Process Sheet

Customer	: CU-DAR001 Dart Helicopters Services		Drawing Name	: BAR
Job Number	: 30146			
Estimate Number	: 10386			
P.O. Number	: N/A		Part Number	: D31961
This Issue	: 04/01/2007 S.O. No. : N/A		Drawing Number	: D3196 UNDER REVIEW <i>OK</i>
Prsht Rev.	: NC		Project Number	: N/A
First Issue	: N/A		Drawing Revision	: U/R
Previous Run	: 29120		Material	: N/A
Written By			Due Date	: 20/01/2007
Checked & Approved By			Qty:	10
Comment	: Est Rev: A New Issue 05-11-08 JLM		Um:	Each
Additional Product				
Job Number: 				
Seq. #:	Machine Or Operation:	Description :		
1.0	M6061T6B0750X01500	6061-T6 Bar .75" X 1.5"

DART AEROSPACE LTD	Work Order:	30146
Description: Bar	Part Number:	D3196-1
Inspection Dwg: D3196	Rev: B-C	Page 1 of 1

FIRST ARTICLE INSPECTION CHECKLIST

D3196-1 BAR

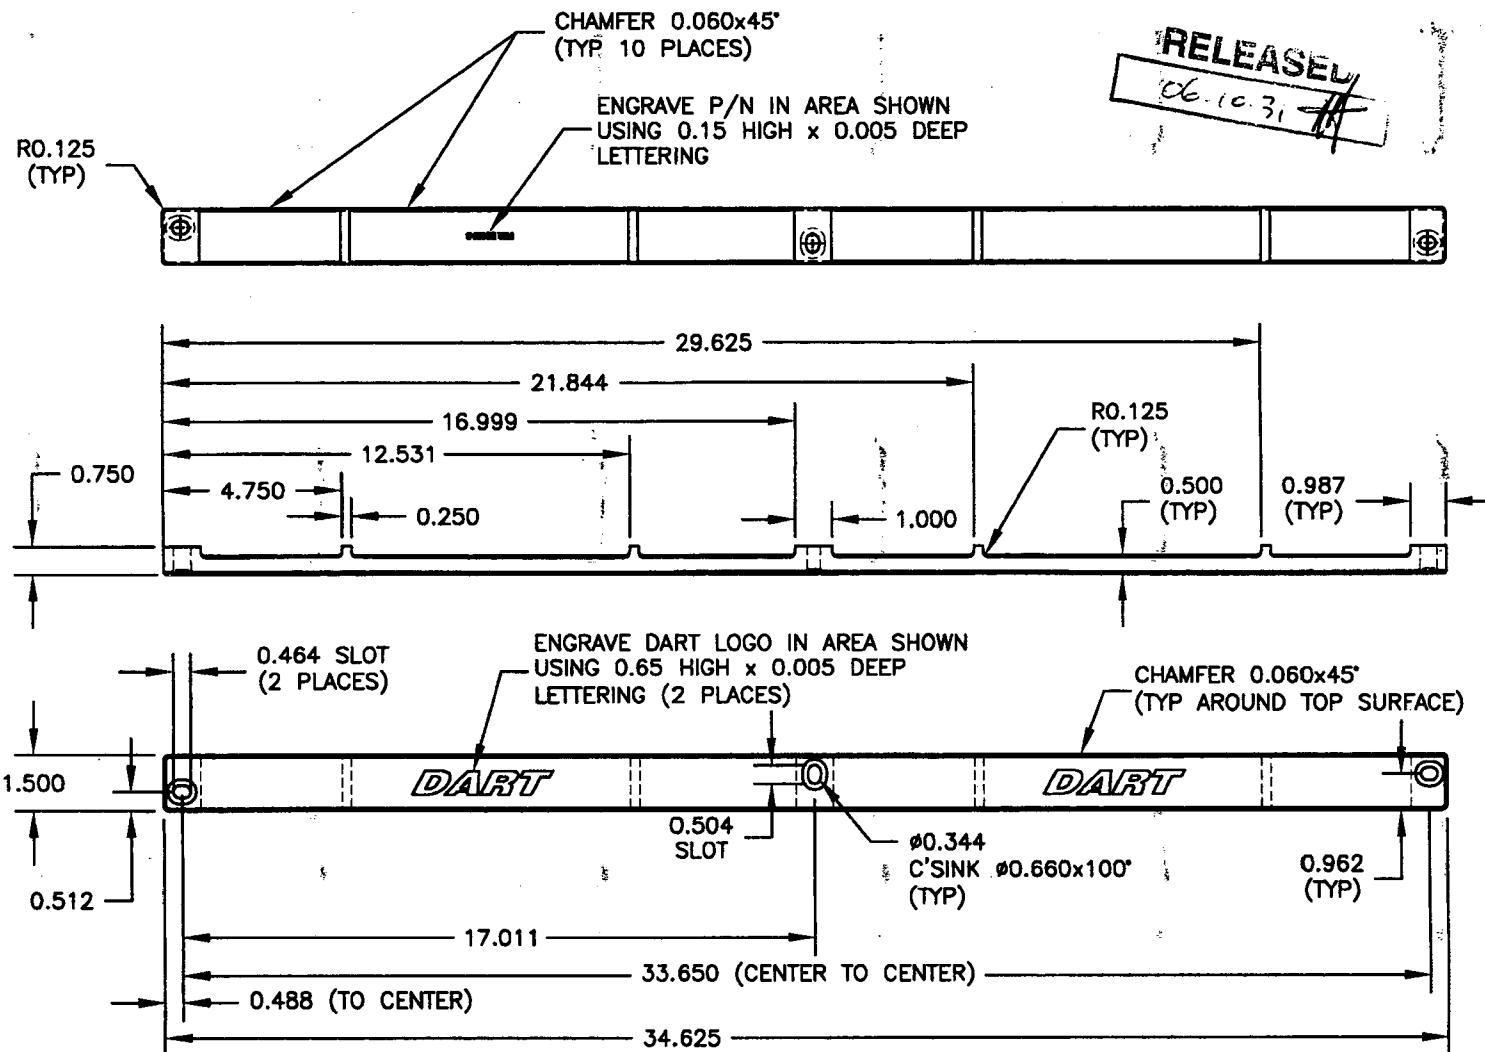
NCR:		WORK ORDER NON-CONFORMANCE (NCR)						
DATE	STEP	Description of NC Section A	Corrective Action Section B			Verification Section C	Approval Design Mgr	Approval QC Inspector
			Initial Design Mgr	Action Description Design Mgr	Sign & Date			
07/01/18	42	are part scrap? Program wasn't changed for the second opp AND Dim. 1.102 is uncorrected on one part by 0.012" and	QSI 042 CP 07/01/18 per QSI 042	Program was changed by SLM. Scraped by good replace. 3.495 dim OK at 3.503 ^{+0.010} STRESS OK BECAUSE THIS WAS	U 07/01/19	07/01/18	QSI 042 07/01/18	07/01/18
07/01/19	3	width by .005". Width of "ped" at holes is 0.97 instead of 1.102".	QI 07/01/19 per QSI 042	KEEP SAME DIM AS REV B OF DWG. PART OK, MARGIN OF SAFETY OF STRESS REPORT UNAFFECTED.	U 07/01/19	07/01/23	QSI 042 07/01/19 per QSI 042	07/01/23

*width of
pad has
no effect
on MS*

*P
07.01.19*
